Metropolitan Parks and Open Space Commission Report

Subject: Minnesota River Greenway Regional Trail Master Plan Amendment, Dakota County, Review File No. 50016-2

Subject: Minnesota River Greenway Regional Trail Master Plan Amendment, Dakota County, Review File No. 50016-2

Figure 1: Minnesota River Greenway Regional Trail (Segment 2) location in the Regional Parks System

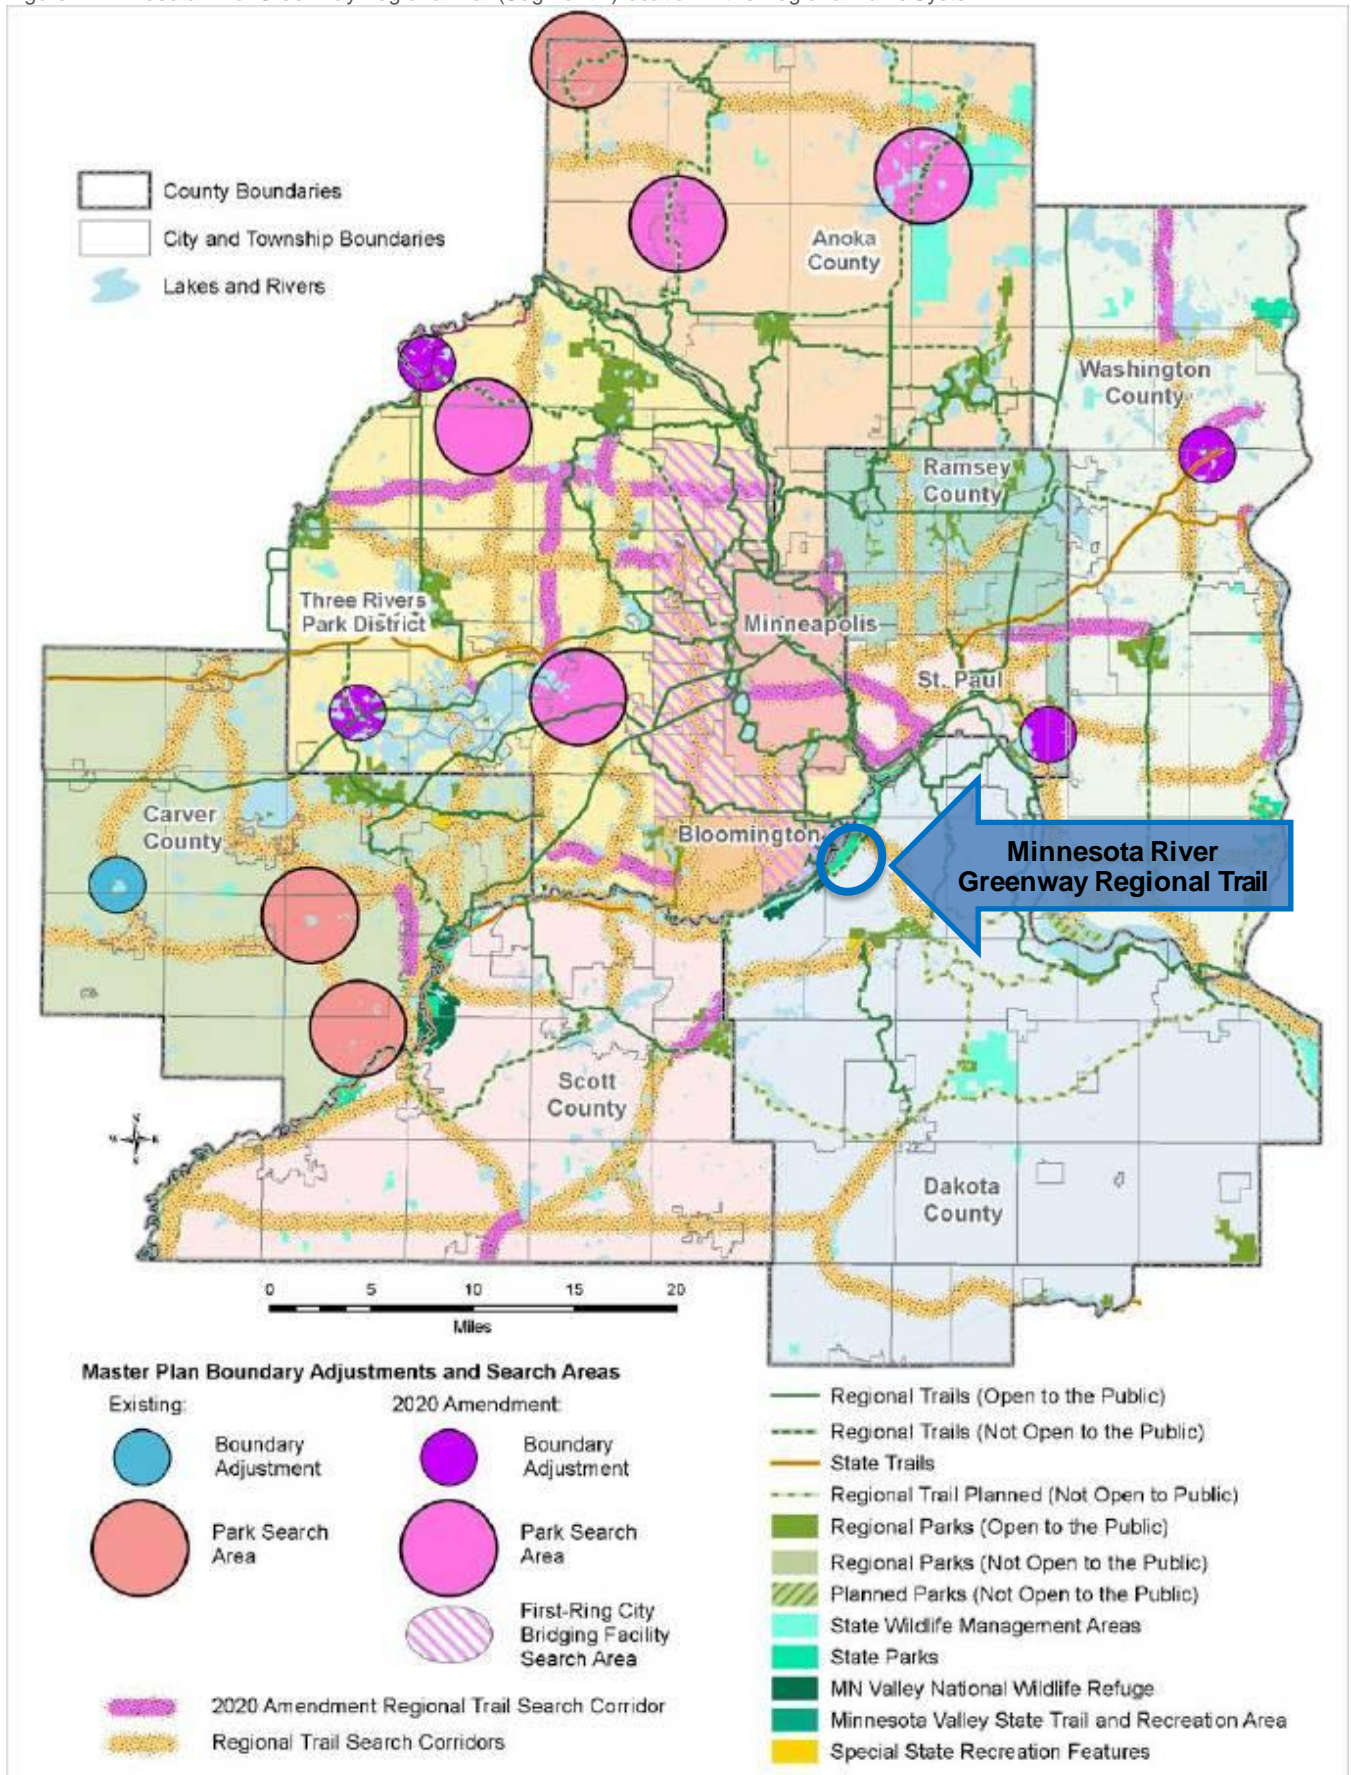
Transportation – Regional Bicycle Transportation Network (Steve Elmer, 651-602-1756) – Given its relevance to regional bicycle planning and potential federal transportation funding for trail construction, it would be advantageous to incorporate language and map elements that describe and reference the Regional Bicycle Transportation Network (RBTN). This could be most easily accomplished by inserting the RBTN route layers into the map shown in Figure 1 of the plan amendment and by adding a short paragraph within the “Development Concept” section.

Figure 3: Minnesota River Greenway Trail (MPA Figure 2)

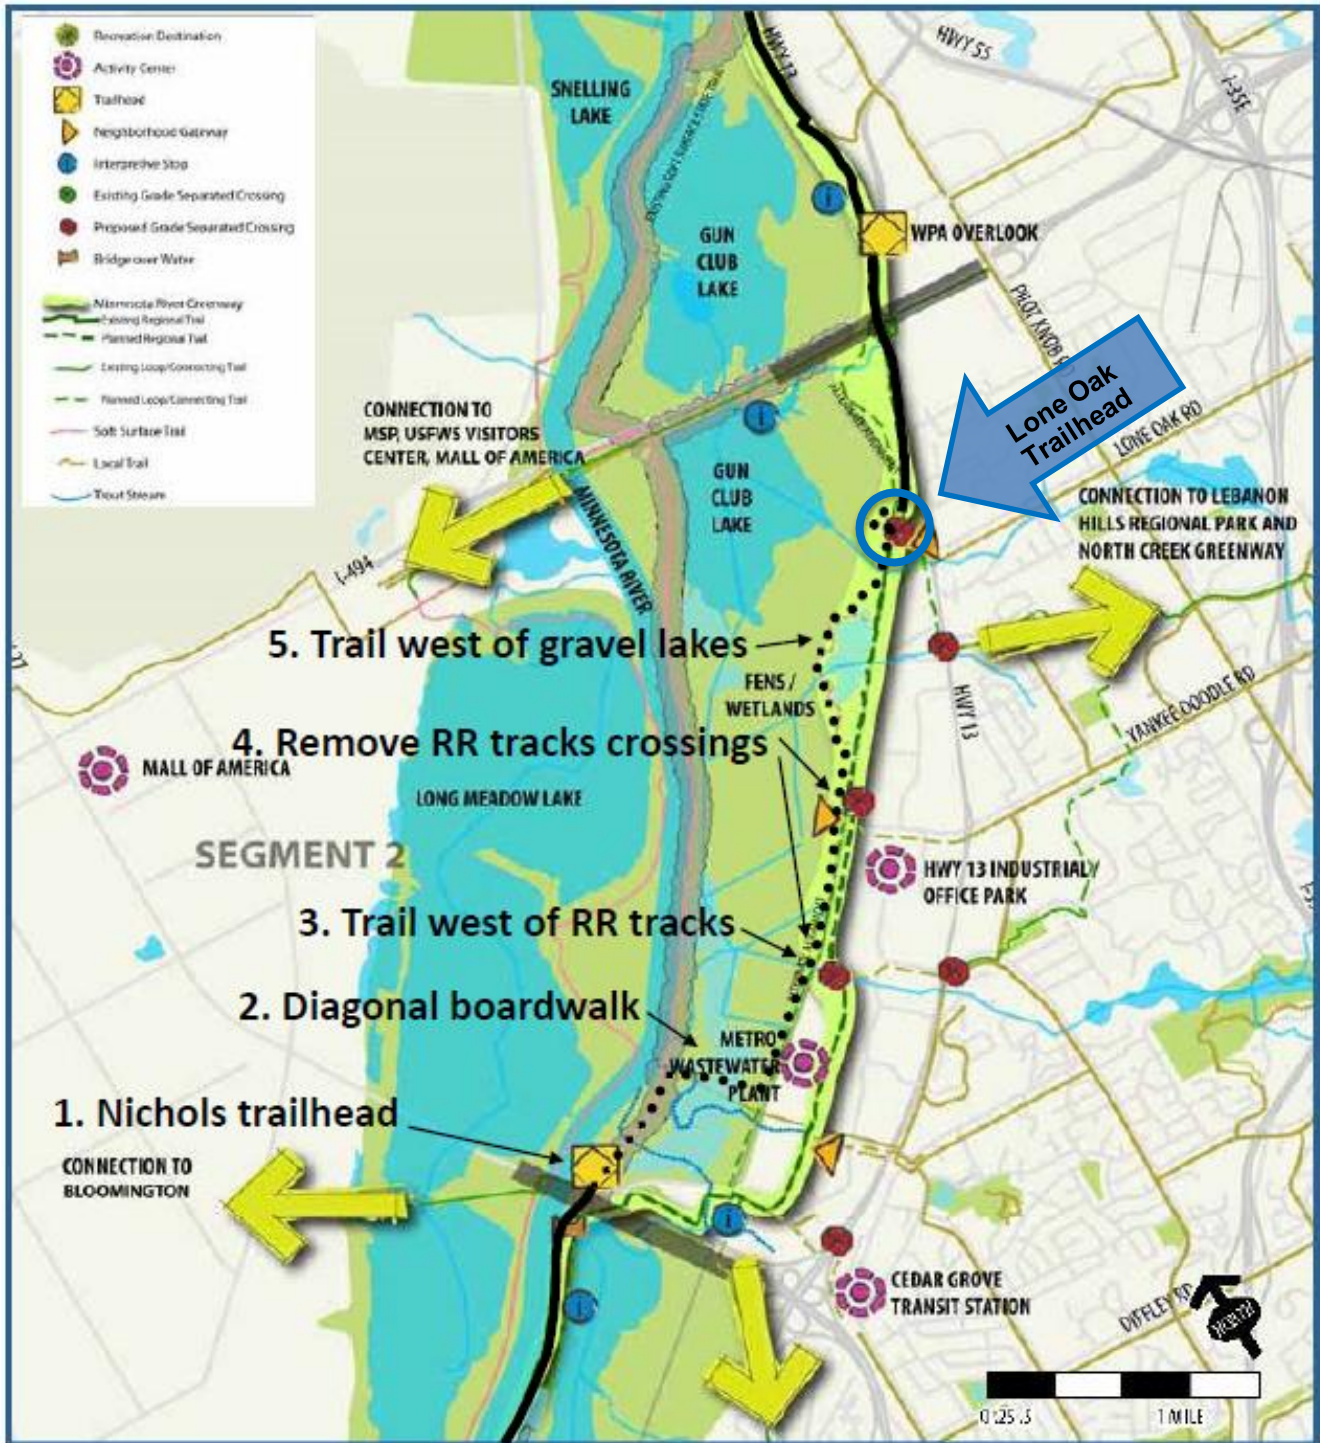
The updated alignment for the Fort Snelling State Park segment of the Minnesota River Greenway Regional Trail appears on Figure 3, overlain on the 2012 Plan concept map. The updated alignment connects and provides a continuous greenway trail from Burnsville to Harriet Island in St. Paul, and then south along the Mississippi River Greenway Regional Trail to Rosemount and Hastings. When complete, this segment will close an important gap between the existing Black Dog segment of the Minnesota River Greenway to the south with the Big Rivers segment to the north.
